SOLICITATION AMENDMENT
MODIFICATION DE L'INVITATION

Title - Sujet Construction Services	
Solicitation No. - N° de l'invitation EZ899-152249/A	Amendment No. - N° modif. 002
Client Reference No. - N° de référence du client	Date 2015-04-14
GETS Reference No. - N° de référence de SEAG PW-\$PWY-019-7491	
File No. - N° de dossier PWY-4-37355 (019)	CCC No./N° CCC - FMS No./N° VME
Solicitation Closes - L'invitation prend fin at - à 02:00 PM on - le 2015-04-24	Time Zone Fuseau horaire Pacific Daylight Saving Time PDT
F.O.B. - F.A.B. Plant-Usine: <input type="checkbox"/> Destination: <input checked="" type="checkbox"/> Other-Autre: <input type="checkbox"/>	
Address Enquiries to: - Adresser toutes questions à: Ngan, Ken (PWY)	Buyer Id - Id de l'acheteur pwy019
Telephone No. - N° de téléphone (604) 658-2755 ()	FAX No. - N° de FAX (604) 775-6633
Destination - of Goods, Services, and Construction: Destination - des biens, services et construction: CBSA - Pleasant Camp Port of Entry - Pleasant Camp, BC

This Solicitation Amendment 002 (Addendum No. 1) is raised to incorporate responses to questions received, to amend the specifications, and to amend the drawings.

Tender A – Pleasant Camp Port o

**STEEL CANOPY GL 7-8
 ROOF PLAN**

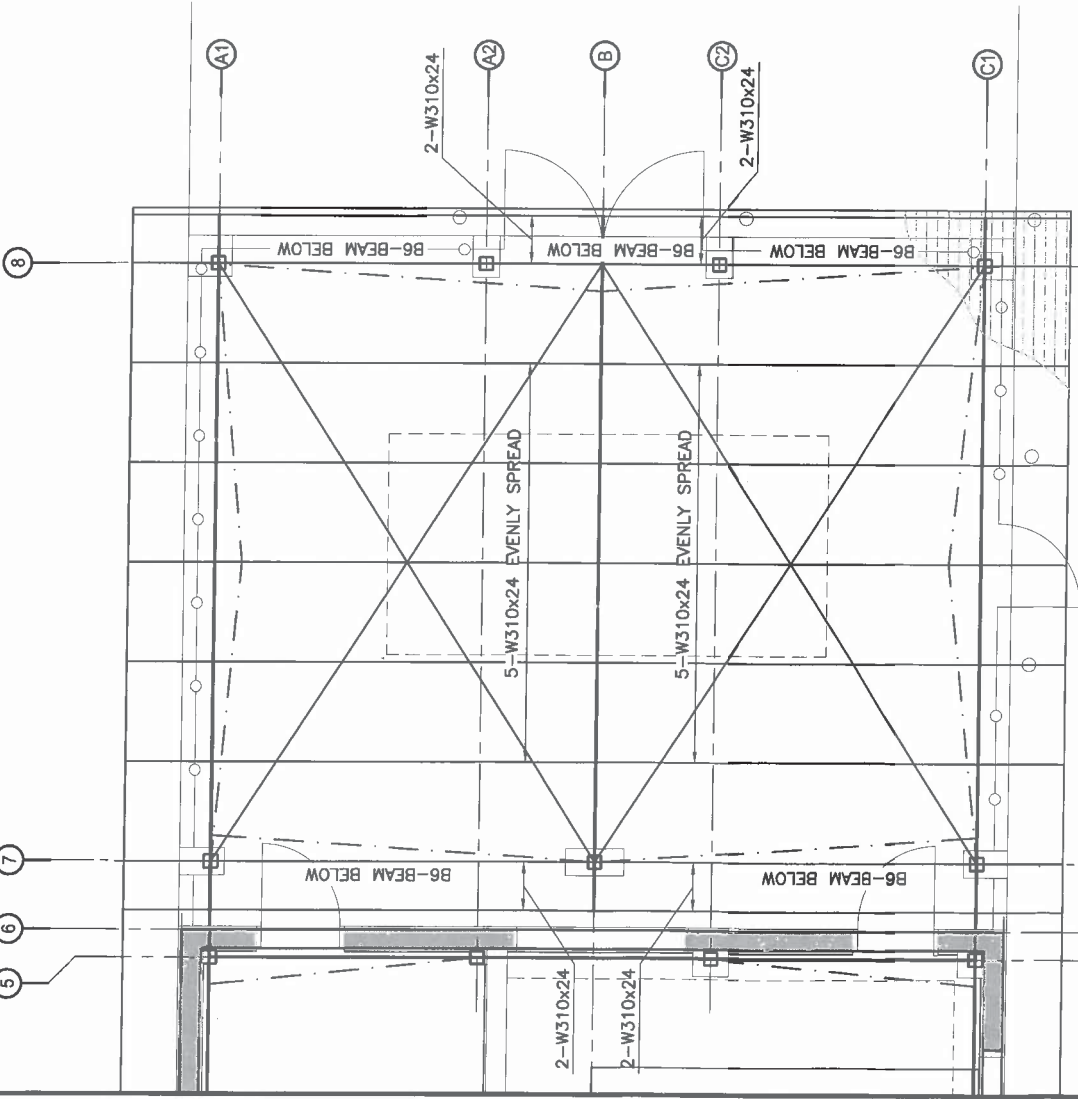
1. Drawing S-001: Change Professional Engineering Jurisdiction references on this drawing from "Yukon Territory" to "the province of British Columbia".
2. Drawing S-102, detail 1:
 - a. Revise steel rafter designation between GL A2-B/7-8: 8-W310x24 evenly spread to 5-W310x24 evenly spread as shown on attached sketch SKS-001.
 - b. Revise steel beam configuration at GL 7&8 as shown on attached sketch SKS-001.
3. Drawing S-301, section 7: Revise horizontal steel beam designation note "STEEL "HSS" BEAM B3 SEE PLAN" to read "STEEL "HSS" BEAM B6 SEE PLAN".
4. Detail 1/E203: Change wire size for OIL WATER SEPARATOR – HEAT TRACE from 2#19 CU to 2#10 CU.

NOTE:
 1. ONLY MODIFIED ITEMS SHOWN, THE ORIGINAL ITEMS SHOWN ON CONSTRUCTION DOCUMENTS STILL APPLY
 2. SEE SECTION 2/S-301 FOR BEAM CONFIGURATION AT GL 7.8
